# UNITED STATES PATENT AND TRADEMARK OFFICE

APPLICATION NO.	FILING DATE	FIRST NAMED INVENTOR	ATTORNEY DOCKET NO.	CONFIRMATION NO.
10/765,969	01/29/2004	Masaki Takabayashi	TAK-168-USAP	2344
28892	7590	03/29/2005	EXAMINER	
SNIDER & ASSOCIATES P. O. BOX 27613 WASHINGTON, DC 20038-7613			SANDY, ROBERT JOHN	
			ART UNIT	PAPER NUMBER

**Office Action Summary**

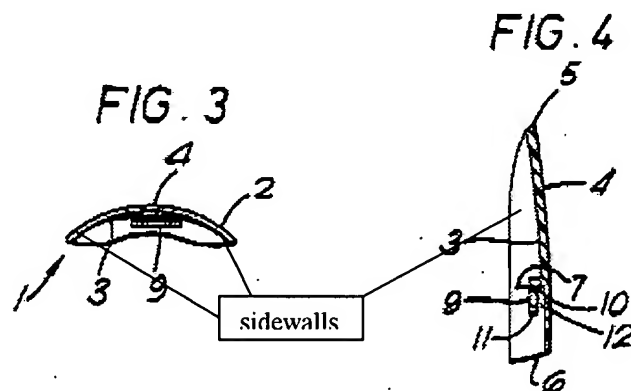
Concerning claims 1, 3, 7 and 9, Aylott ('123) discloses a decorative artificial nail cover (1) which comprises: a cover body (2) extending to an end of the cover with a curved surface like a human nail; and a thin plate wall (9) formed in an inner surface of the cover body and running sideways along the cover body; wherein a fitting ditch (12) is formed on the thin plate wall between the wall and the inner surface of the cover body.

Concerning claims 2, 4, 8 and 10, Aylott ('123) discloses decorative artificial nail cover (1) which comprises: a decorative cover body (2) with a decorative surface (4) and having in a rear portion a pair of side walls (see Figs. 3 and 4 provided herein) directed downward and facing each other; a thin plate wall (9) formed in an inner surface of the cover body and directed toward each side wall; and wherein a fitting ditch (12) is formed on the thin plate wall between the thin plate wall and an inner surface of the cover body.
